Subject: Interstate 4 from East of SR 15/600 (US 17/92) to ½ Mile East of SR 472 Value Engineering Study Recommendation Dispositions

FM: 408464-2

Interstate 4 from East of State Road 15/600 (US 17/92) to 1/2 Mile East of State Road 472

Value Engineering Study **Draft** Report

RECOMMENDATION No. 25: Relocate the Park 'n Ride and the pond to the property west of the Riverside Condominiums on Dirksen Drive

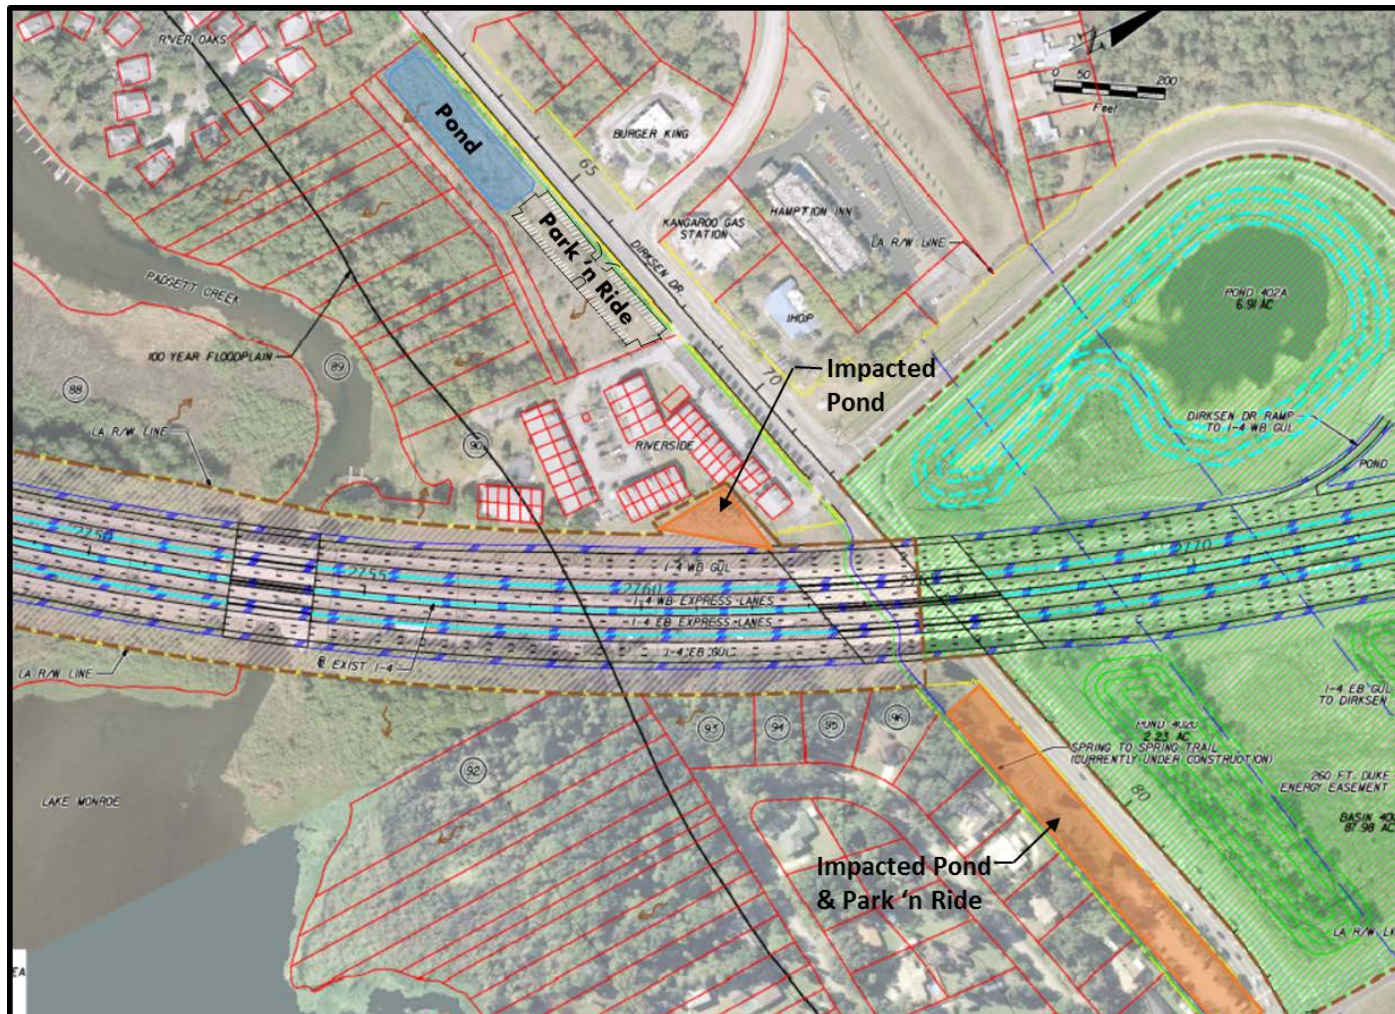
The PD&E Documents show a proposed I-4 eastbound exit ramp to eastbound Dirksen Drive that causes the existing Park ‘n Ride in the southeast quadrant of this interchange to be eliminated. It also encroaches on the existing pond that is adjacent to the Park ‘n Ride. There is currently no proposed relocation for the Park ‘n Ride or the FDOT pond at the condos.

Consider buying the property west of the Riverside Condominiums to provide the space that is needed for the relocation of the Park ‘n Ride and since this Park ‘n Ride would be adjacent to a trail, it could also serve as a Trail Head. This property could also be used for the additional pond area that is needed.

Recommendation 25: Relocate the Park and Ride and the pond to the property west of the Riverside Condominiums on Dirksen Drive

Accepted. The parcel just west of the Riverside Condominiums is the new location for the Park and Ride lot that was impacted due to the new I-4 eastbound off ramp to eastbound Dirksen Drive.
